# CITY OF SAN ANTONIO

RE: Raintree POADP  
Amendment dated July 2, 1986  
File #83-20-63-44

PRELIMINARY OVERALL AREA DEVELOPMENT PLAN  
for  
**RAINTREE SUBDIVISION**  
"A Morton Southwest Development"

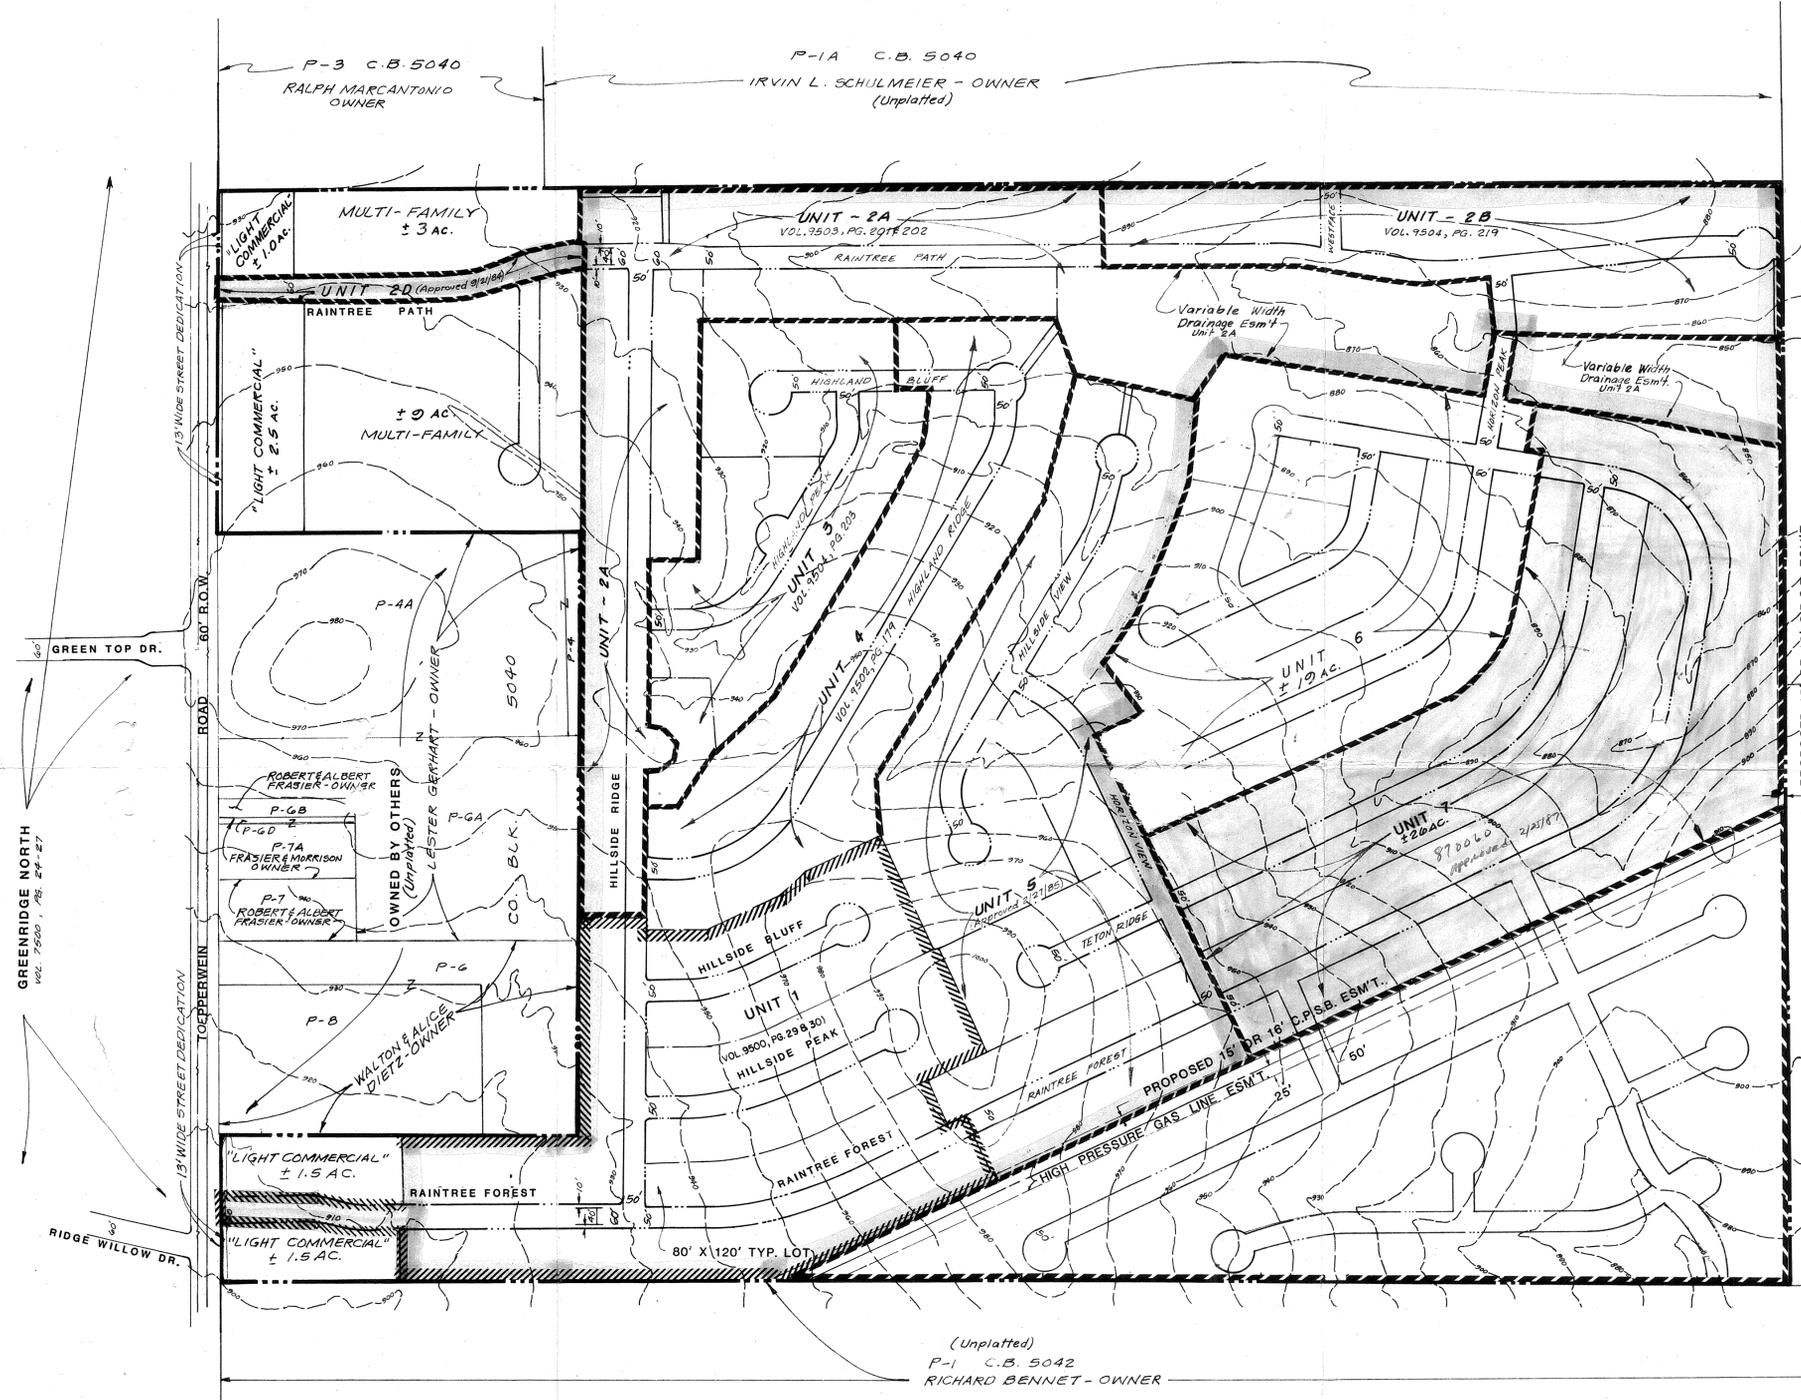
This is to inform you that the POADP committee has reviewed and accepted your plan of Raintree.

Indicates recommended link to accommodate proper circulation.

The Committee expressed concern about what it considers to be an unnecessarily long cul-de-sac street in Unit-9 and recommends that a loop street be provided to lessen the cul-de-sac street length (see attached plan). The Committee also requests that the stub streets in Unit-9 be eliminated.

The above has been reviewed by the P.O.A.D.P. committee and has determined that it is in general compliance with the Subdivision Regulations. The revised plan reflects a new street design in Unit-6 which is acceptable to the committee. Overall, our comments regarding cul-de-sacs and Major Thoroughfares as noted to you on our memo dated April 11, 1983, are still valid.
